1722B – PROPOSAL FOR LARGER BUS_ID SIZES FOR CAN & LIN

DON PANNELL
02 DEC 2019

IEEE 1722b – Larger bus_id size – The Need

IEEE 1722b – Larger bus_id size – Proposal for CAN

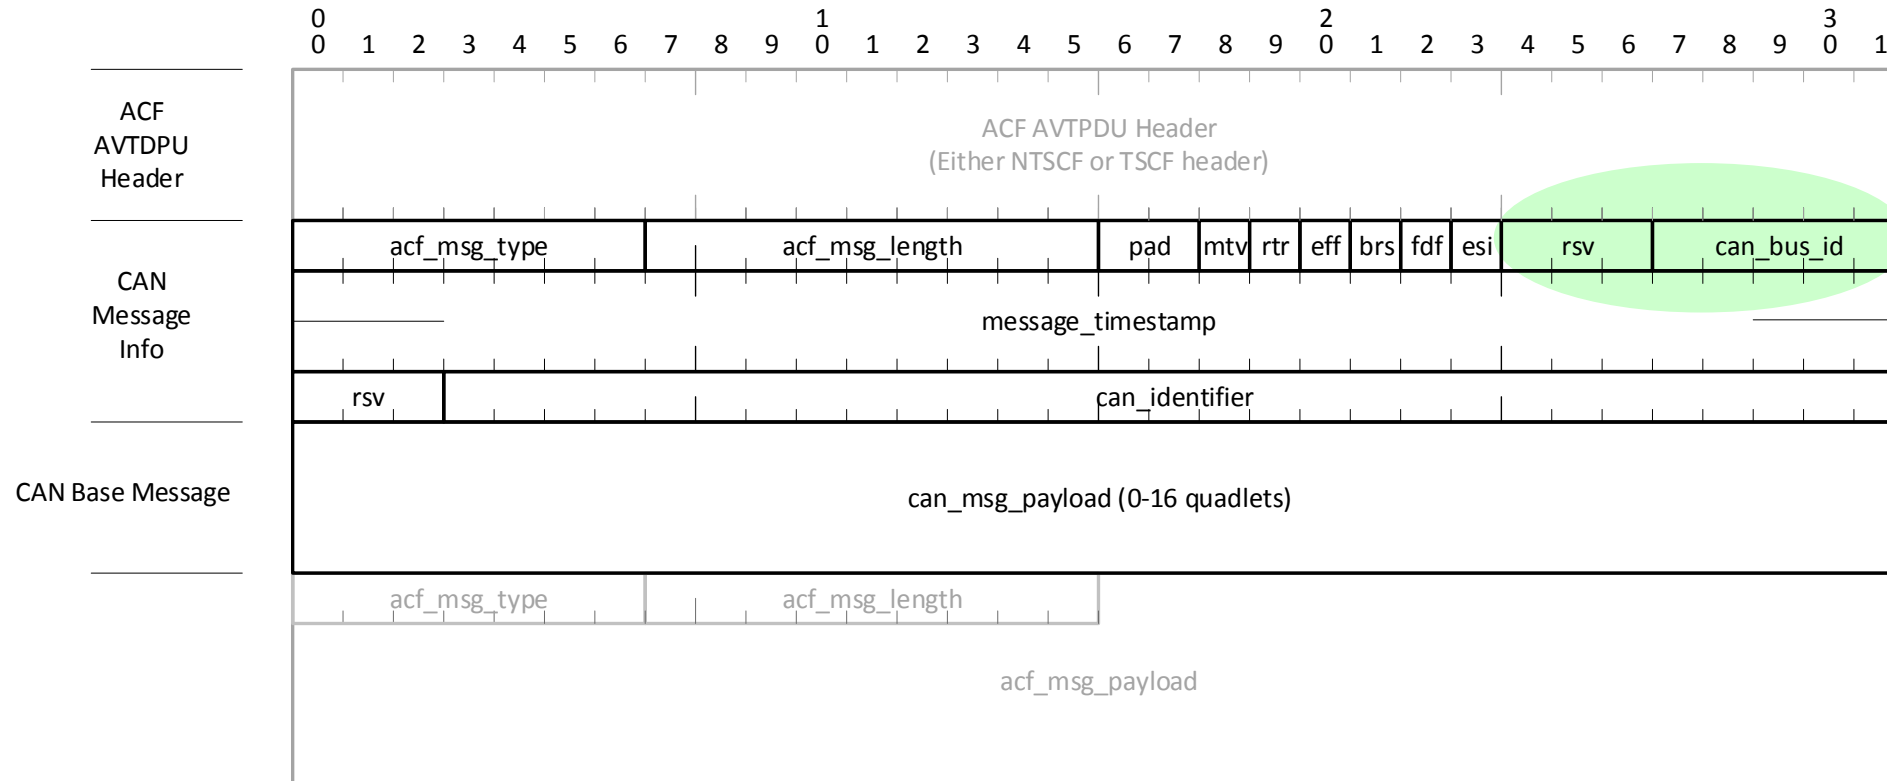
- The can_bus_id is easy to extend to an 8-bit field as there are 3 reserve bits next to the upper can_bus_id bit
- Same adjustment works for both ACF_CAN & ACF_CAN_BRIEF message types

IEEE 1722b – Larger bus_id size – Proposal for LIN

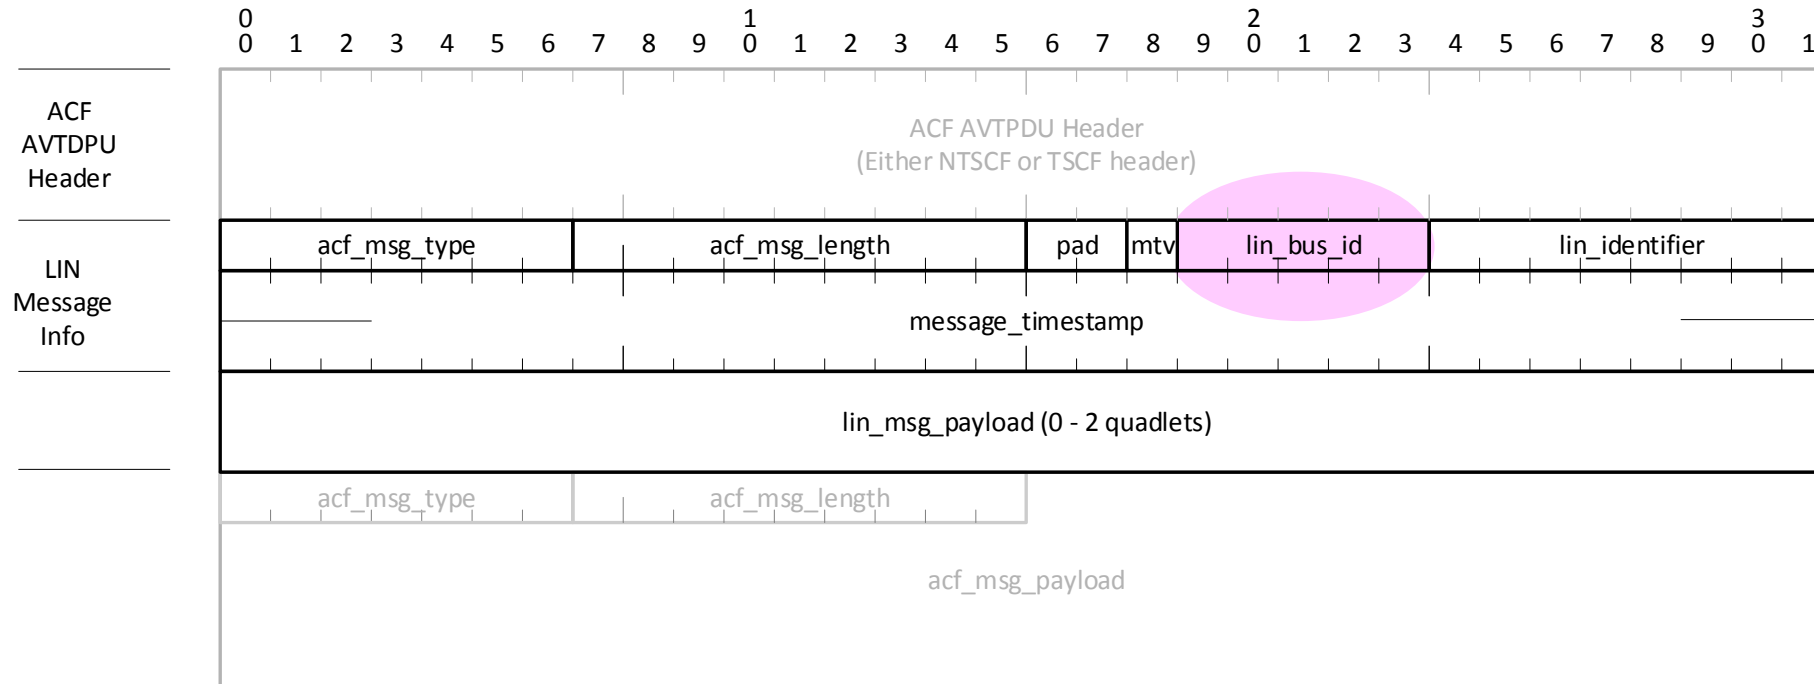
- The lin_bus_id is not so easy to extend but it is the one hitting the 5-bit limit faster
- For LIN there are many possible ways to extend the lin_bus_id, all of which make the frame a quadlet bigger, unless the upper byte of the message_timestamp is used

IEEE 1722b – Larger bus_id size – Proposal for LIN

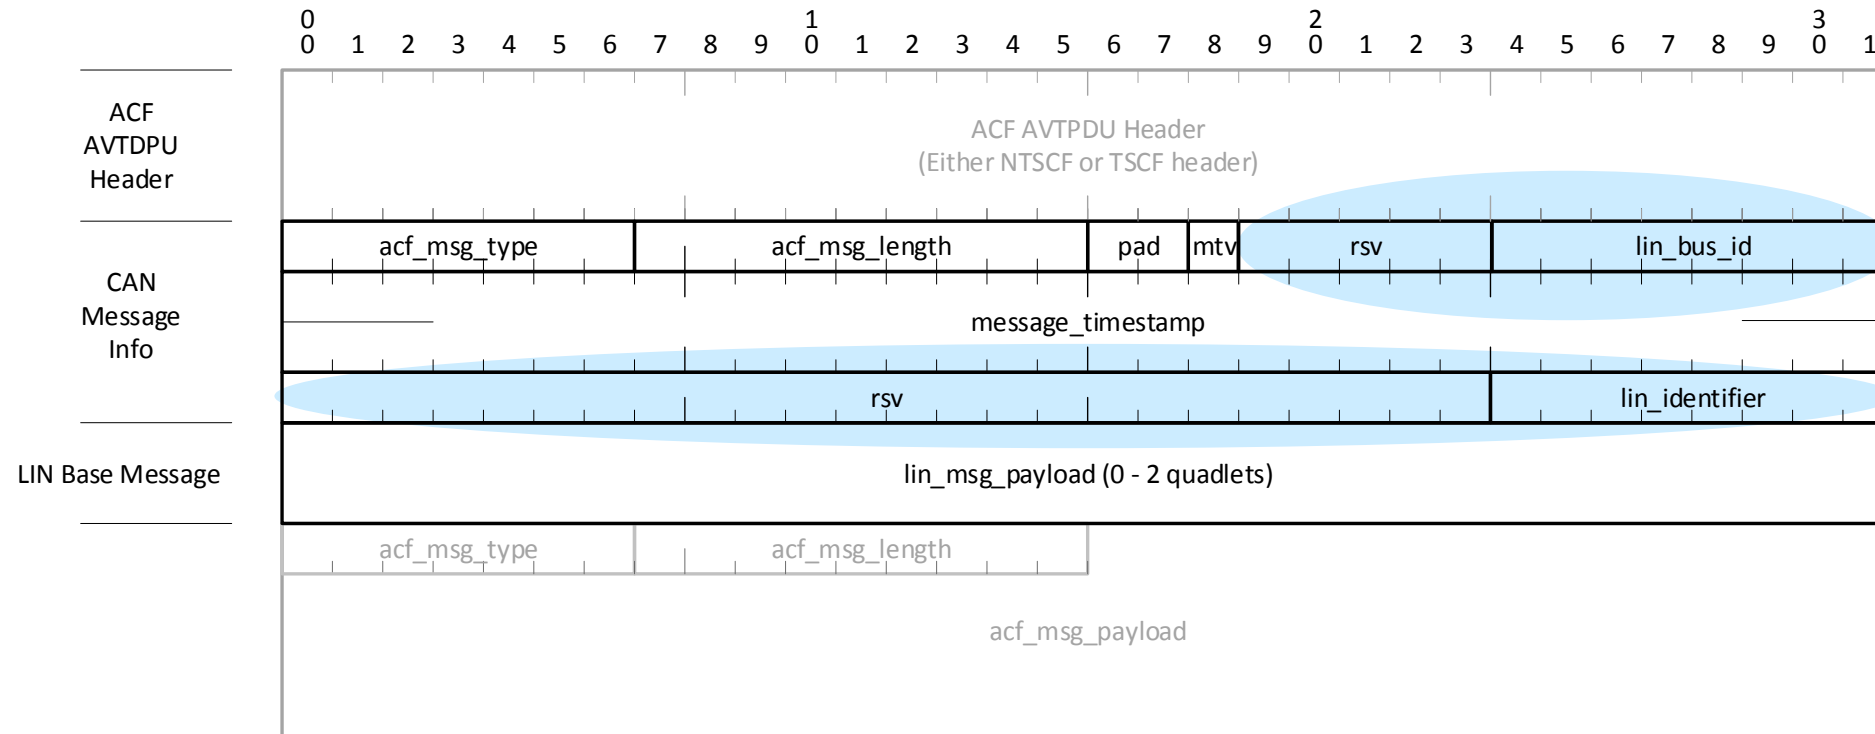
- If the frame size is increased by a quadlet, then maybe it is best to make the LIN frame more like the CAN frame as shown below
 - All the common fields are in the same place as can be seen by flipping this slide with the next slide

IEEE 1722b – Larger bus_id size – Proposal for CAN - again

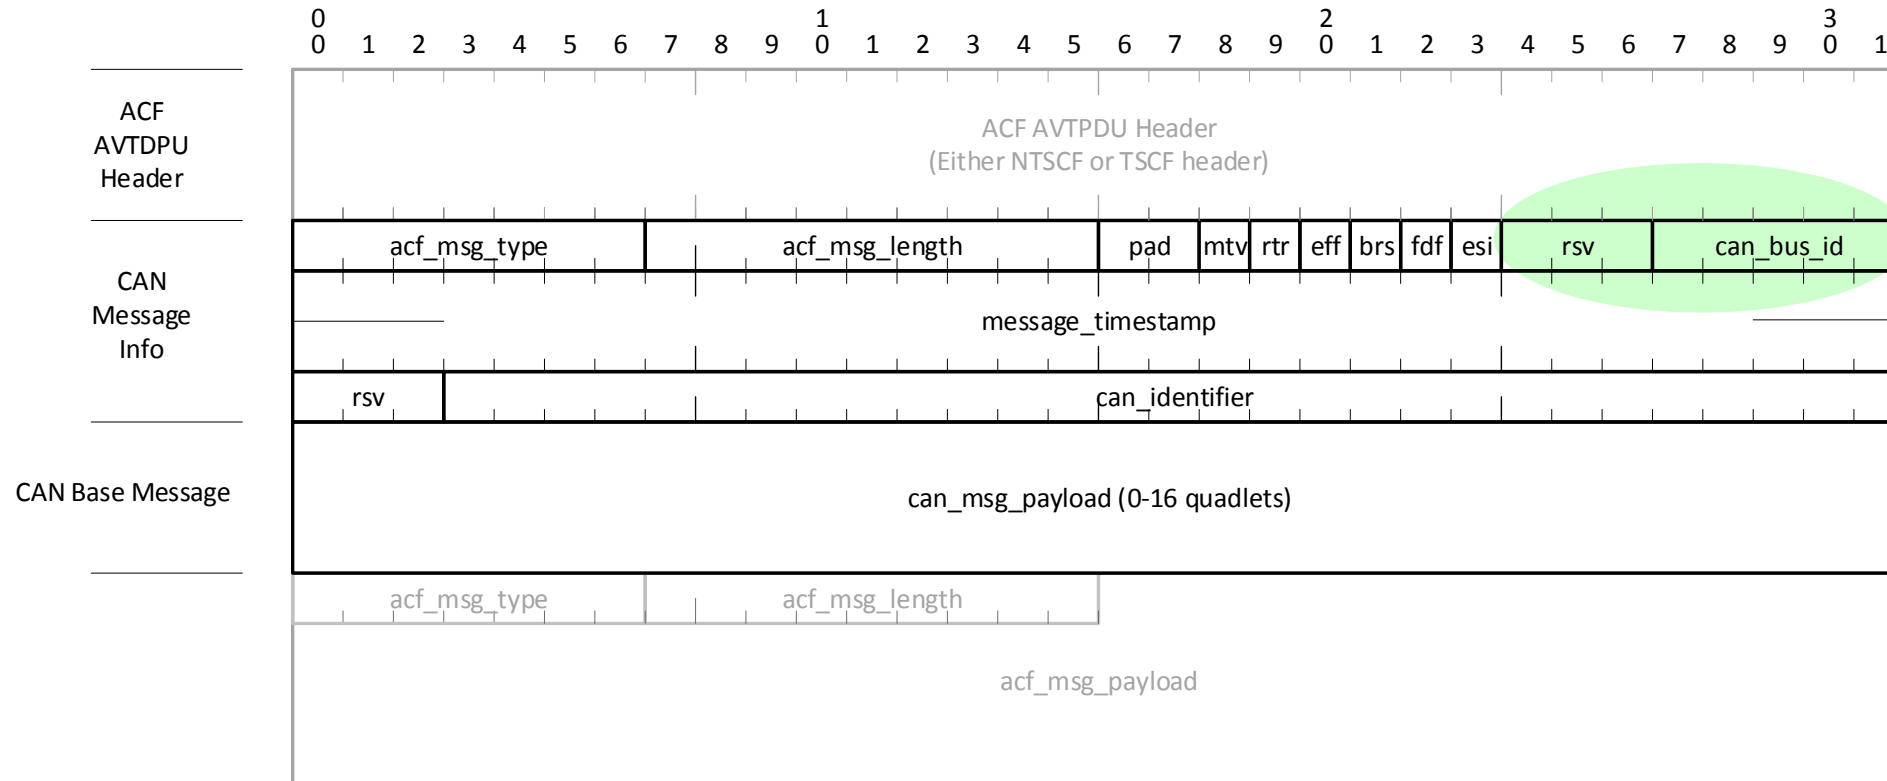
- This is re-shown here so that flipping between this slide and the previous slide is easy to see the common field layout between CAN & LIN
